Docket Item # 3
BAR CASE #2010-0281

BAR Meeting
October 20, 2010

ISSUE: Alterations (Window and Door Replacement)
APPLICANT: Erin Germany by Old Town Windows and Doors
LOCATION: 207 South Payne Street
ZONE: RM / Residential

Figure 7. Proposed replacement window specifications

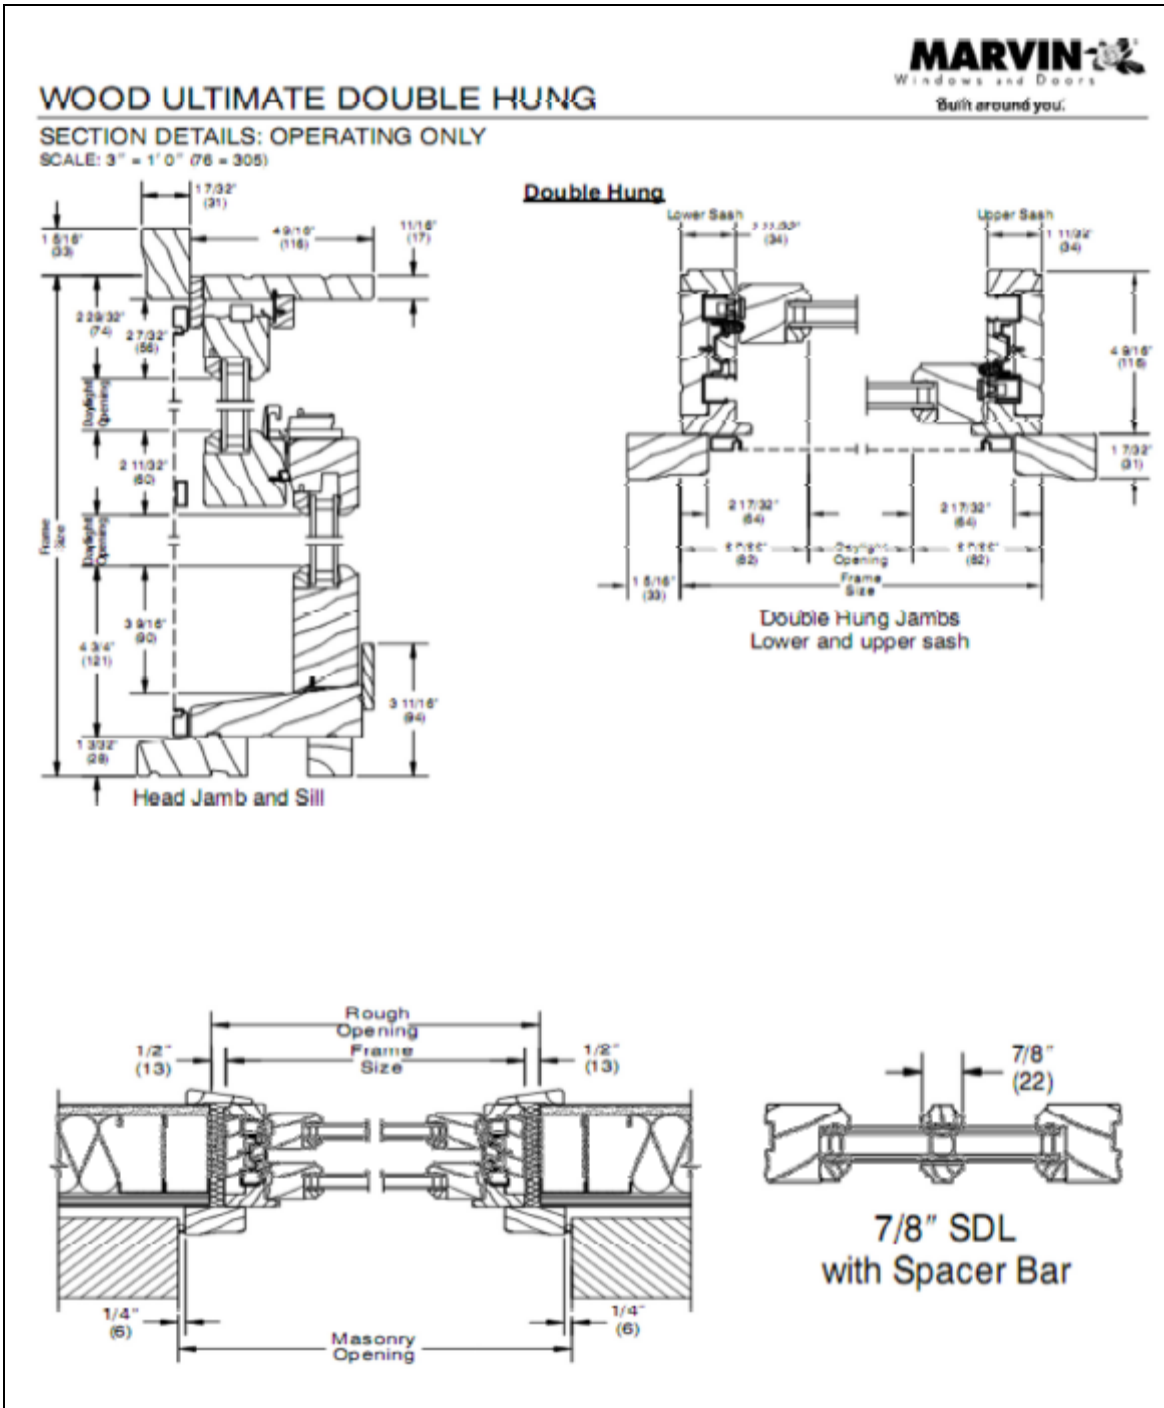
- Frame: Solid Pine Wood Frame (1 1/16" thick)
- Sashes: Pines Wood Interior and Exterior Sashes with Butt Joint, Mortise and Tenon Sash Corners
- Jamb Liner: Wood Jamb Liner or liner to be minimal from the exterior
- Grilles:
 - Fixed wood grilles (muntin) on the interior and exterior
 - Muntins to maintain a faux putty glaze profile on the exterior
 - Stiles, Rails and Muntins to match existing dimensions
 - Simulated Divided Lite (SDL)

- Spacer Bars: Dark in Color
- Installation: Full Frame
- Exterior Trim: Profile to replicate existing
- Screens: Removable Half or Full Screens
- Glazing: clear, LoE3-366 with Argon
- Weather-strip: Continuous foam filled bulb weather strip at the head-jamb, jambs, check rail and bottom rail
- Balancer System: Block and Tackle Balancer System

Therefore, given the age of the townhouse and the fact that the existing light pattern and putty glazed muntin profile and size of the windows and French doors will be retained, Staff does not object to the installation of new double-glazed wood windows and doors with simulated divided lights. Staff finds the proposed replacement windows and doors appropriate and compatible with the surrounding buildings. The applicants will provide final specifications for each window and door to be installed when applying for the building permit.

Staff evaluates each proposed replacement window against the draft *Alexandria Window Performance Specifications*. The windows proposed by the applicant appear to meet these specifications

Figure 8. Proposed replacement French Door specifications

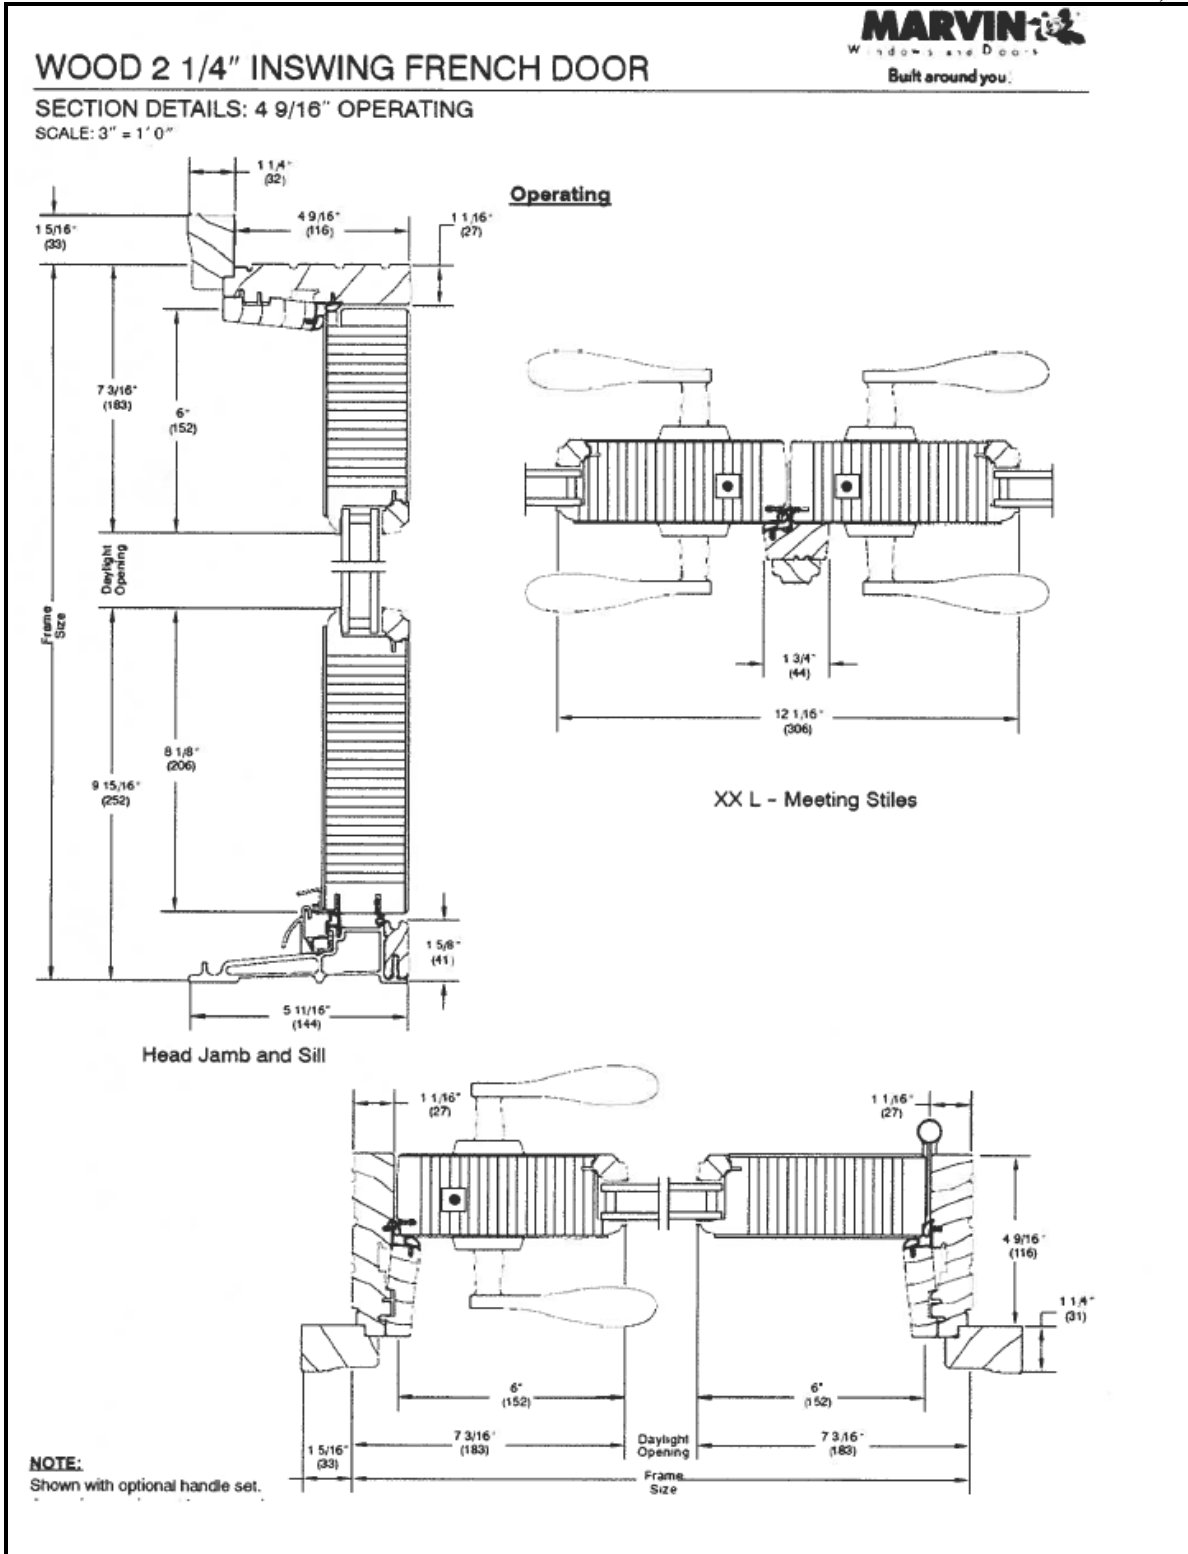
- Frame: Solid Pine Wood Frame (1-1/16" thick)
- Stiles and Rails: Pines Wood Interior and Exterior with Butt Joint, Mortise and Tenon Sash Corners
- Grilles:
 - Fixed wood grilles (muntin) on the interior and exterior
 - Muntins to maintain a faux putty glaze profile on the exterior
 - Simulated Divided Lite (SDL)

- Spacer Bars: Dark in Color
- Installation: Full Frame
- Exterior Trim: Profile to replicate existing
- Screens: Full Hinged Aluminum Screens
- Glazing: clear, Tempered - LoE3-366 with Argon
- Weather-striping: Head and Side Jamb to have 2 sets of bulb weather-strip. Threshold to have bulb weather strip
